FIRE SAFETY INSPECTION REPORT

PRETTY SWEATERS LTD.

ACCORD ID: 12192

April 20, 2015

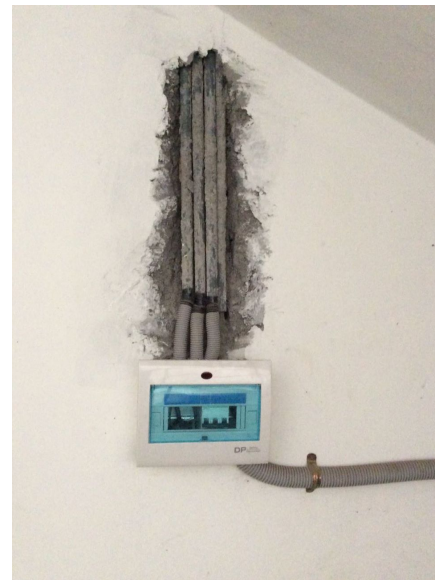
F-2	Fire Rated Construction	The north east and west exit stairs are not separated from work areas and other spaces on each floor by fire-rated construction.	Provide minimum 1.5-hr fire rated doors for buildings that are 4 or more stories. Seal all unprotected openings to separate the exit stairs from work areas and other building spaces on all floor levels. Ensure that the fire doors are self-closing and positive latching and that they are provided with fire exit (panic) hardware where serving production floors.	Within 3 months
-----	-------------------------	--	--	-----------------

If fire doors are required to be held open for functional reasons, provide automatic-closing devices tied to the fire alarm system.

Once fire doors are installed, every door in a stair enclosure serving more than 5 stories shall be provided with re-entry unless it meets ACCORD standard 6.8.3.1.

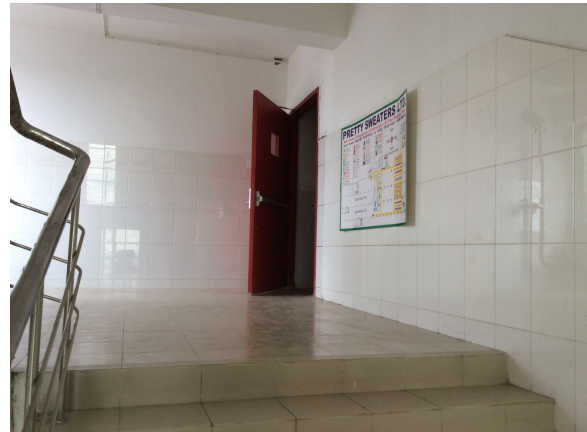
F-12	Egress	Building did not have stair designation signs at exit stairs. Building did not have occupant load signs at factory floors.	Provide stair designation signs and occupant load signs at required locations.	Immediately
------	--------	--	--	-------------

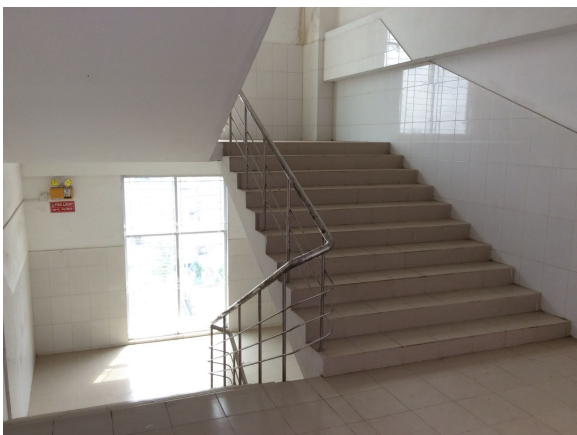
F-17	Egress	Handrails are not provided on both sides of the exit stairs and ramp.	Provide handrails on both sides of the exit stairs and ramp. New handrails shall have a minimum height of 865 mm (34 in.) and a maximum height of 965 mm (38 in.) as measured from the leading edge of the tread. Intermediate handrails shall be provided when the stair width exceeds 2.2 m (87 in.)	Within 3 months
------	--------	---	--	-----------------

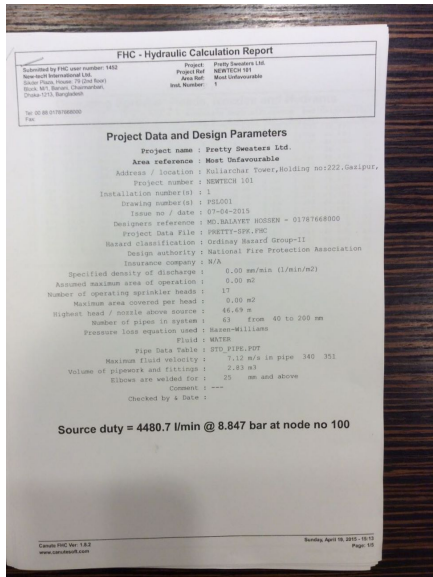
F-26	Fire Protection	Fire pump did not meet ACCORD standard 5.5.1 and 5.5.1.1.	Update current fire pump or provide a new fire pump that meets ACCORD standard 5.5.	Within 6 months
------	-----------------	---	---	-----------------
